Minor Amendment to Site Plan - EPC for adjustments in response to soil and drainage conditions, accessibility requirements, and reviewer comments at building permit.

RE: Andalucía Senior Housing Site Plan and Related Applications

The purpose of this letter is to request approval of a Minor Amendment to the Overture at Andalucia Site Plan – EPC based on changed conditions and design changes necessitated during development of the building permit drawings due to platting, accessibility, and soil conditions. The subject site is legally described as Tract 4, Plat of North Andalucia at La Luz containing approximately 7.7 acres and is located at 5301 Antequera Road NW.

**Overture Andalusia Senior Housing
PROPOSED NAME OFSITE DEVELOPMENT PLAN**

SHEET NUMBER
CG-100

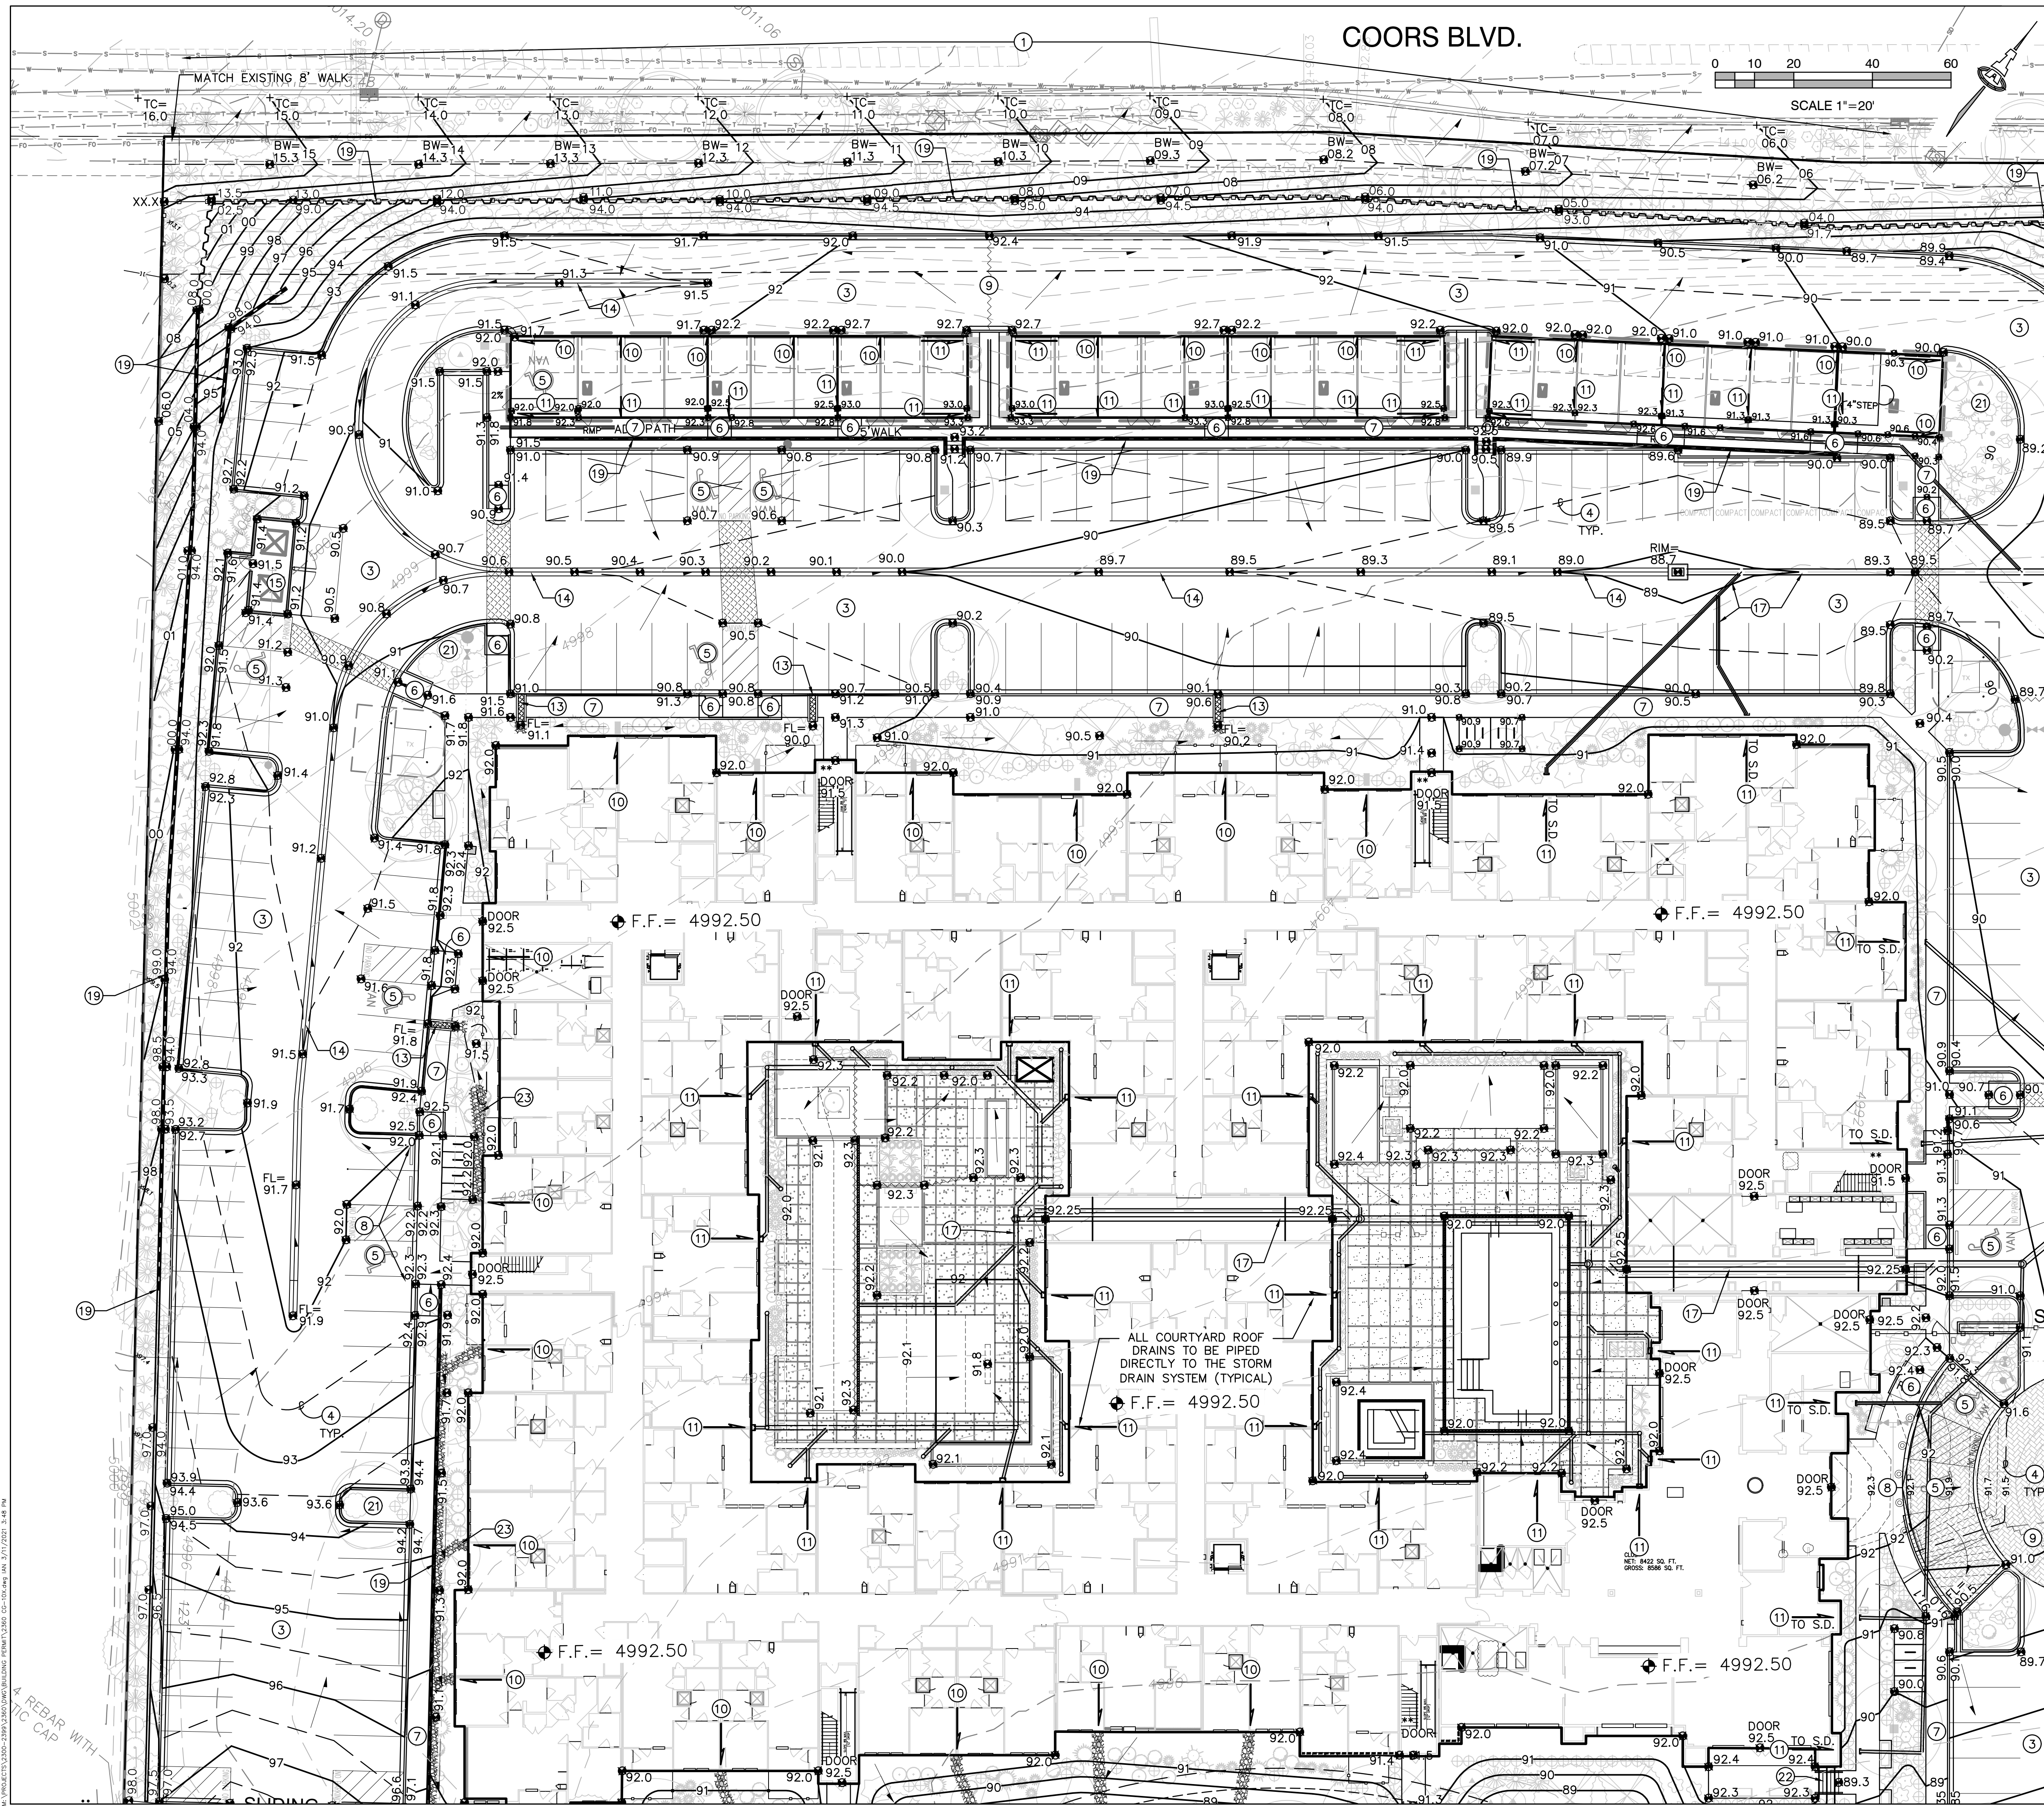
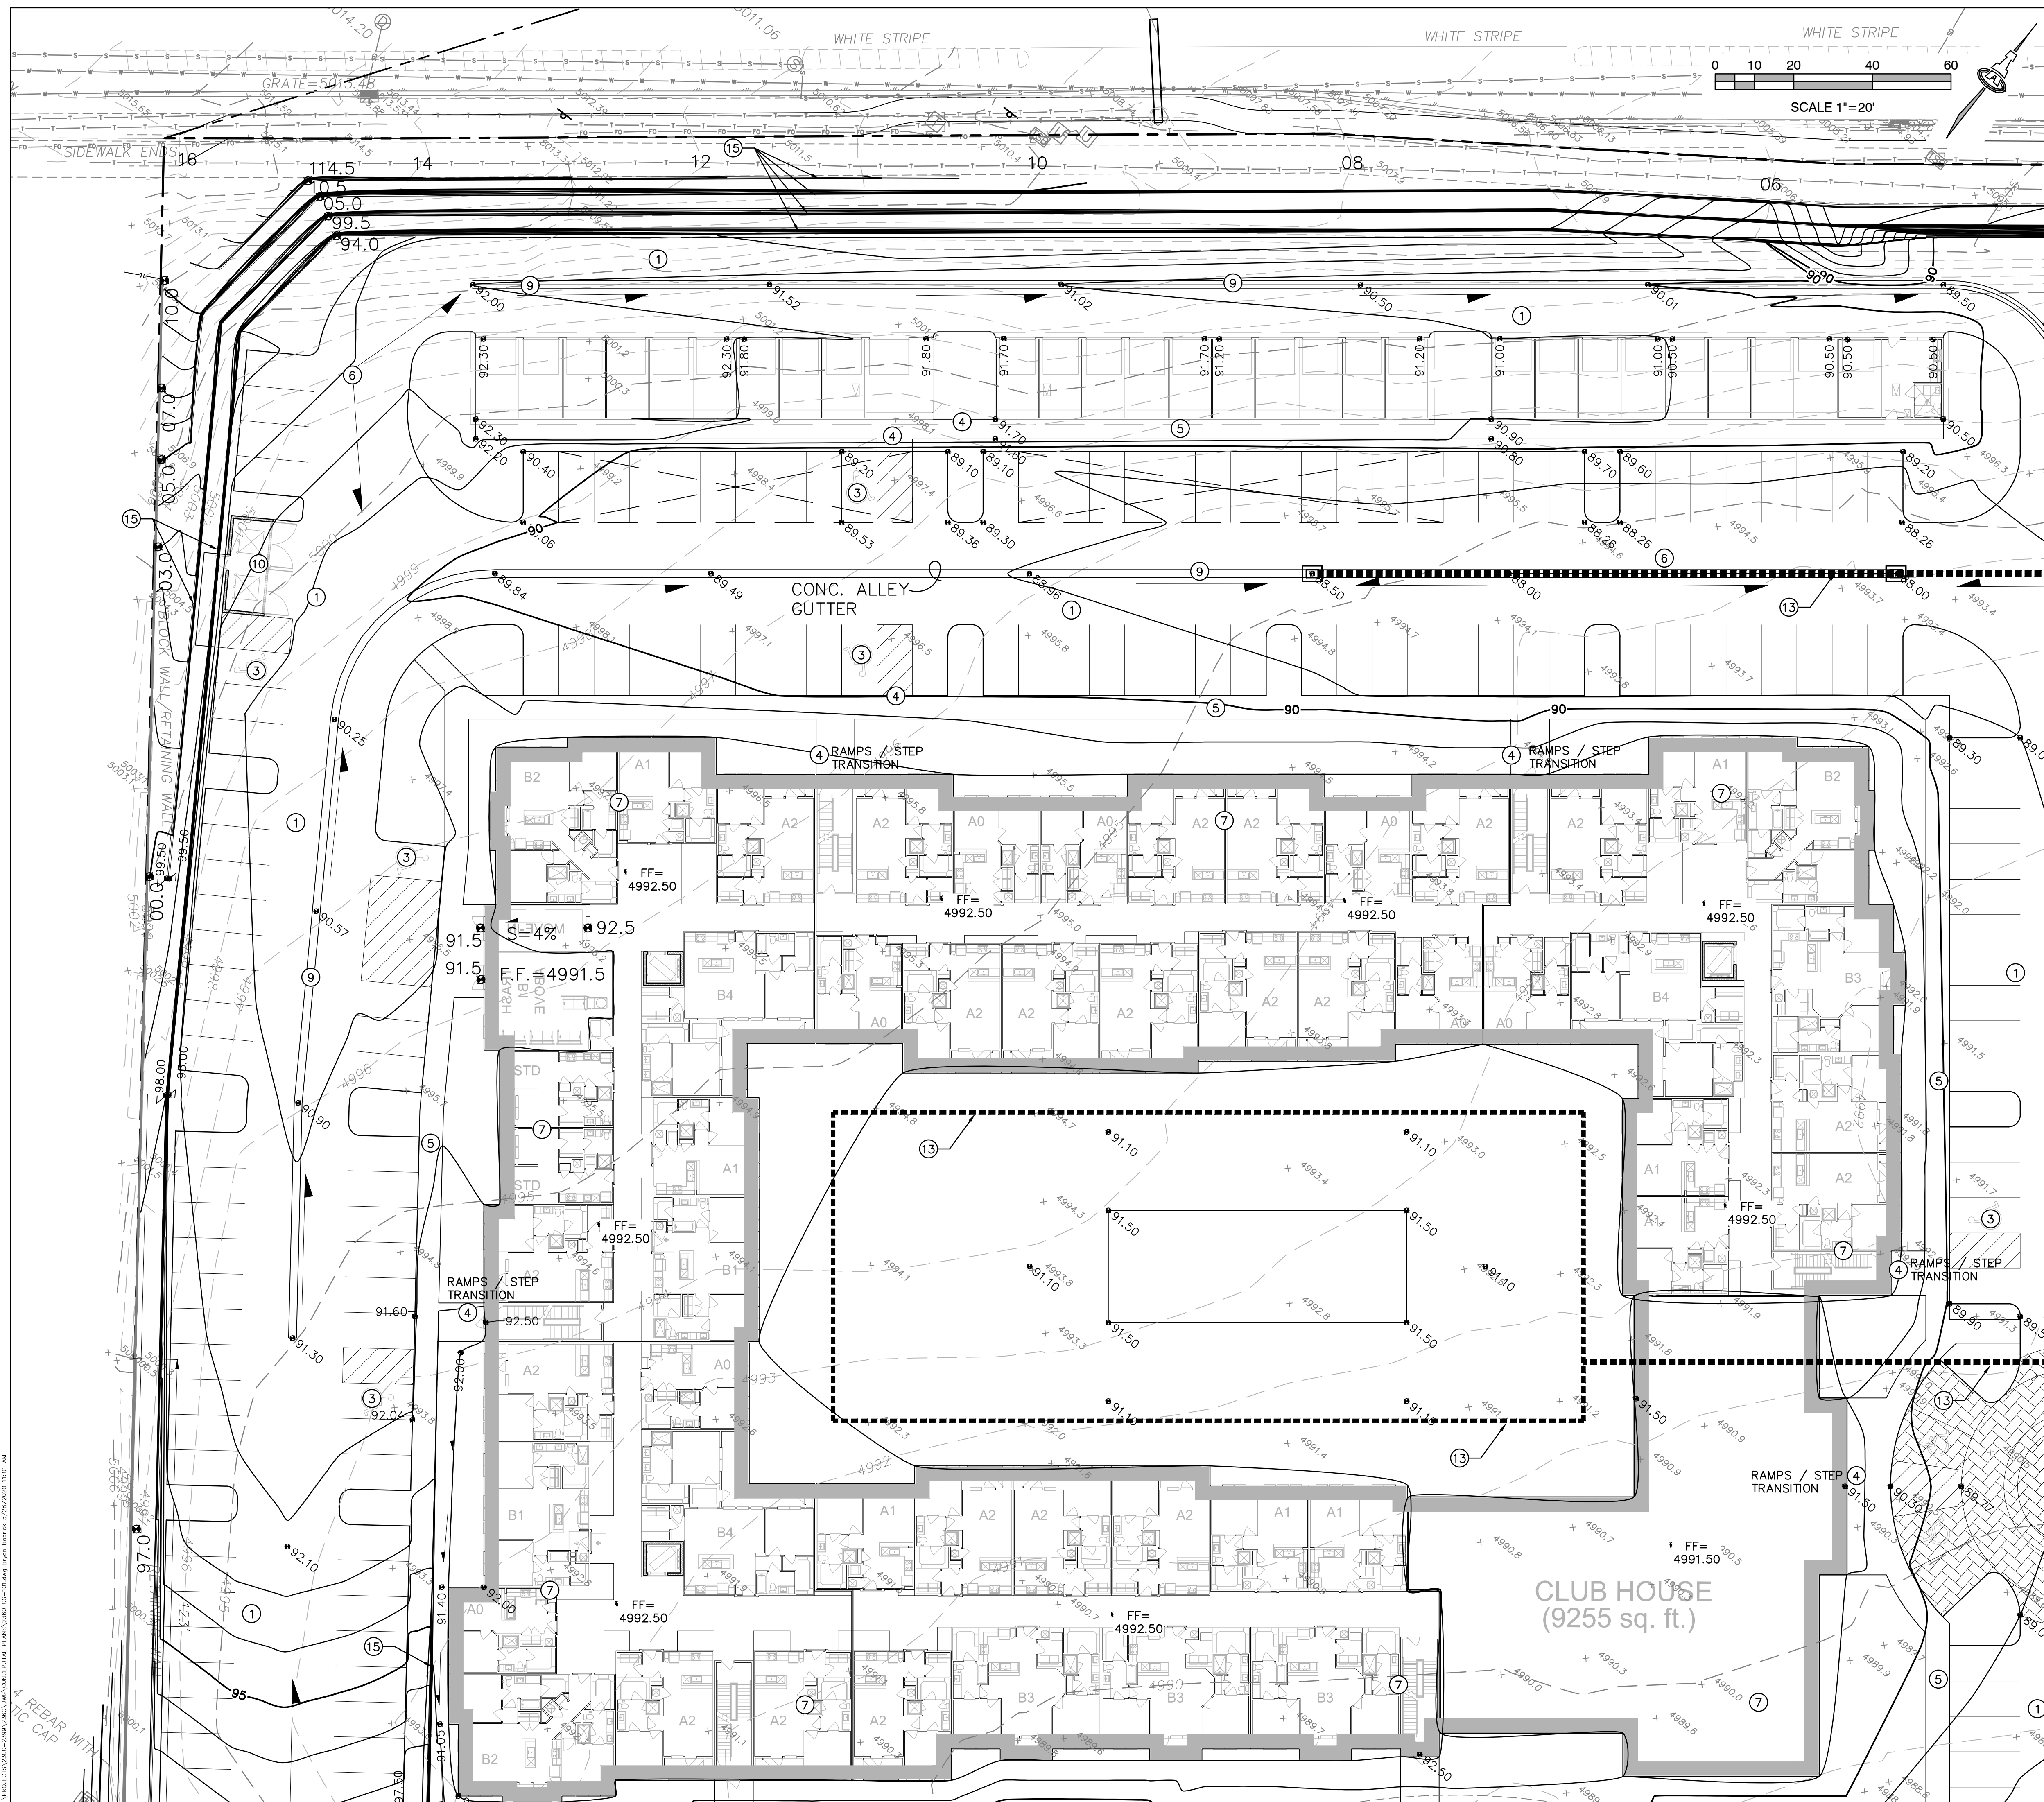
1. Consultation on final design of the retaining walls along Coors Boulevard with a geotechnical engineer revealed that the soils would likely undercut the Coors Boulevard right-of-way during construction of the proposed multi-tiered retaining wall. To solve this issue, a Corten steel sheet pile wall is proposed along a portion of this edge of the property.

These changes are clouded and noted on the attached revised Site Plan, details, and elevation sheets. The Grading and Drainage plan was resubmitted and approved by Hydrology staff for the new retaining wall and updated site plan. Lastly, the Landscape Plan was updated to reflect minor adjustments to the landscape areas and tree placements to match the changes on the site plan.

Based upon the information provided in your submittal received 03/11/2021, the Grading and Drainage Plan is approved for Building Permit, Grading Permit, Paving Permit, and Work Order.
